Key Technical Issue Container Life and Source Term CLST 2.01

April 2004

Prepared for:
U.S. Department of Energy
Office of Civilian Radioactive Waste Management
Office of Repository Development
1551 Hillshire Drive
Las Vegas, Nevada 89134-6321

Prepared by:
Bechtel SAIC Company, LLC
1180 Town Center Drive
Las Vegas, Nevada 89144

Figure 1. Pertinent Components of Drip Shield

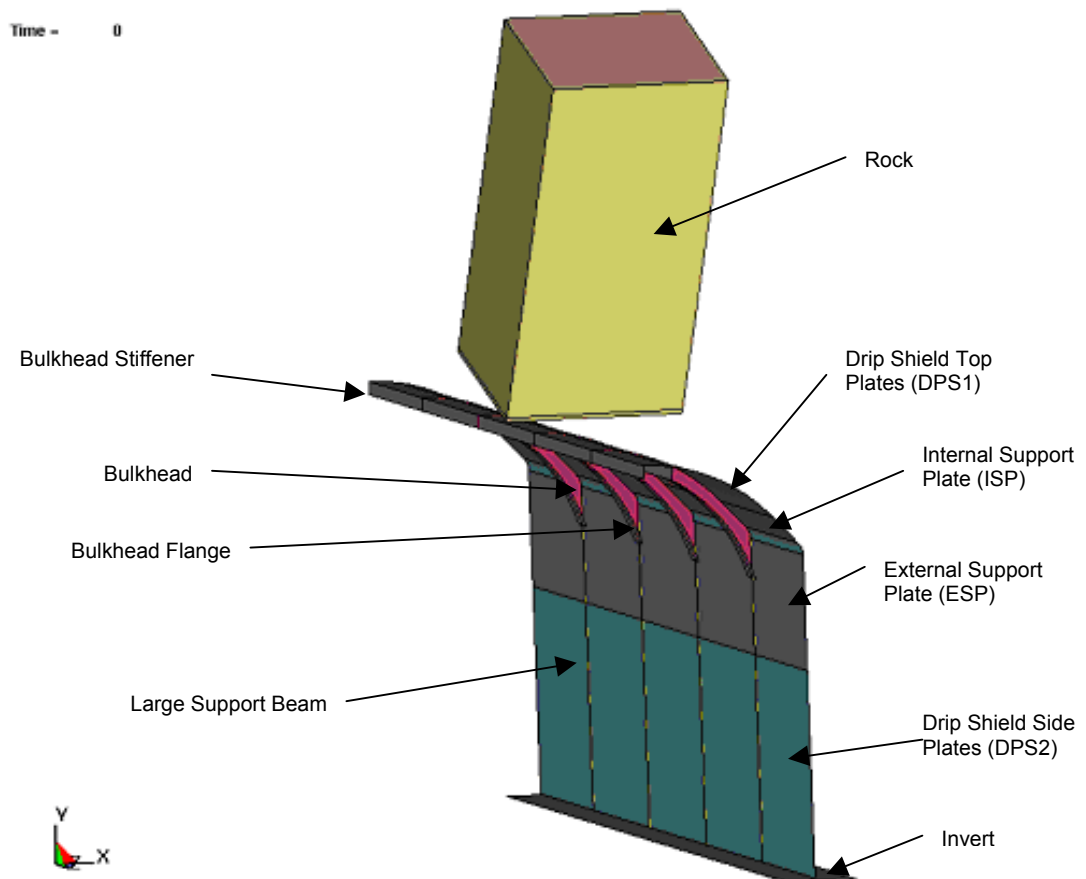
“Either provide documentation using solid element formulation, or provide justification for not using it, for the drip shield – rock fall analysis. DOE stated that shell elements include normal stresses and transverse stresses in the calculations and provide more accurate results for thin plates and use far fewer elements. Therefore, shell elements will be used instead of solid elements. This justification will be documented in the next revision of AMR ANL-XCS-ME-000001, Design Analysis for the Ex-Container Components, prior to LA.”

Finite element analysis calculations are performed by using the commercially available LS-DYNA V960 code (BSC 2002). A representative calculation is documented in, *Drip Shield Structural Response to Rock Fall* (BSC 2004) and the calculation is included as Appendix A. In this calculation, the drip shield is subjected to a point-loaded 14.5 metric ton rock fall in the center of a drip shield top plate (DSP1) (see Figure 1).

These analyses provide the residual stress values that are used in the assessment of postclosure stress corrosion susceptibility of DSP1 and drip shield side plates (DSP2). Residual stresses are determined on the basis of exceeding 50% of yield strength of Titanium 7.
